Subject: Submission re DA 2019/1230

Comments on DA 2019/1230 36 Karina Crescent BELROSE 2085

Submitted by:
John and Janis Buggy
7 Lord St
BELROSE 2085

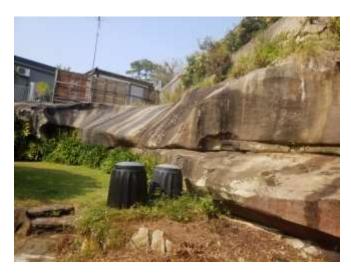
- 1. The "deck". It appears that it is the concreted area close to the house and not the paved area around the pool
- 2. The "pool fence". This should refer to the fence surrounding the pool. However, the metal fence on the eastern side of the pool continues across the width of the property as there is a steep drop over the sandstone escarpment to the land below. This part of the existing fence should not be referred to as a pool fence. It is more of a safety fence.
- 3. The "proposed paving area". This refers not just to paving around the existing pool area but paving over a planned extension towards the rear boundary. The

term "new paving" does not differentiate between the existing pool surrounds and the proposed extension.
